PROJECT: Genesee County Animal Shelter
Site & Building Improvements

ADDENDUM NO: Three

PROJECT NO.: 17001700

DATE: June 11, 2018

SHEET NO.
A-5.3
 OF

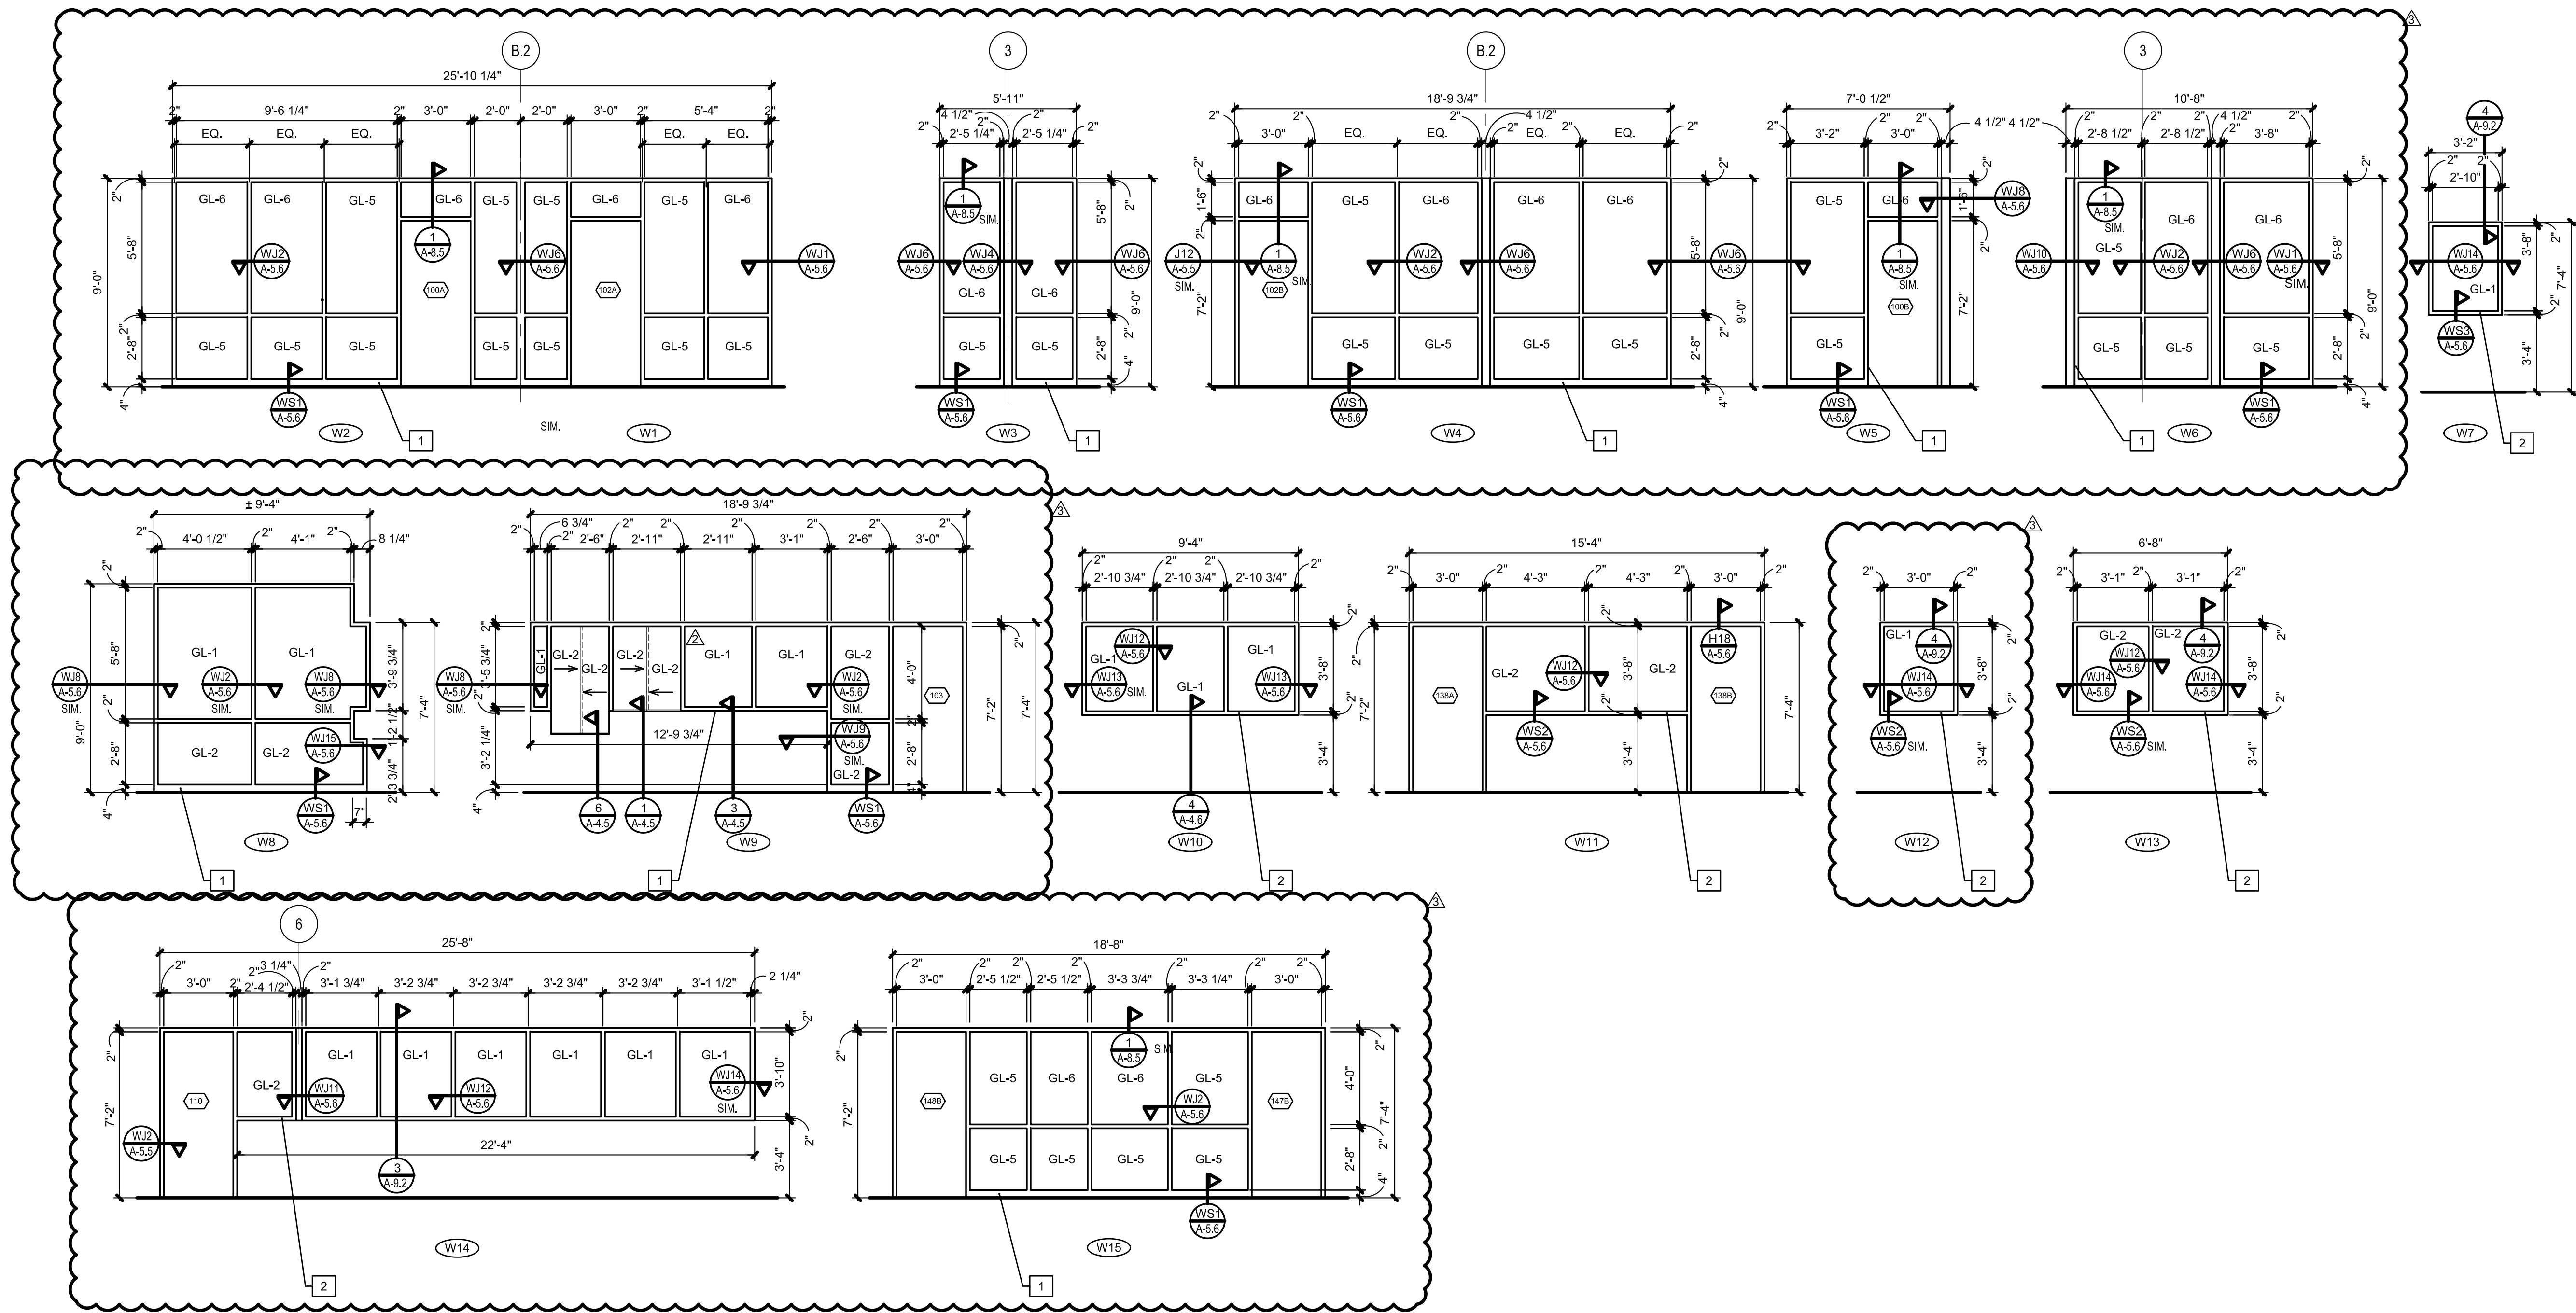
1. Sheet A-5.3 Window Schedule (Re-issued)
Item A: Glass types and detail targets have been modified on several windows.
Item B: Notes have been revised under “Schedule of Glass Types”.
2. Sheet A-5.6 Door and Window Head, Jamb, and Sill Details (Not Re-issued)
Item A: WJ2 detail modified to show center set glazing.
Item B: WJ3, WJ5, and WJ7 details eliminated.
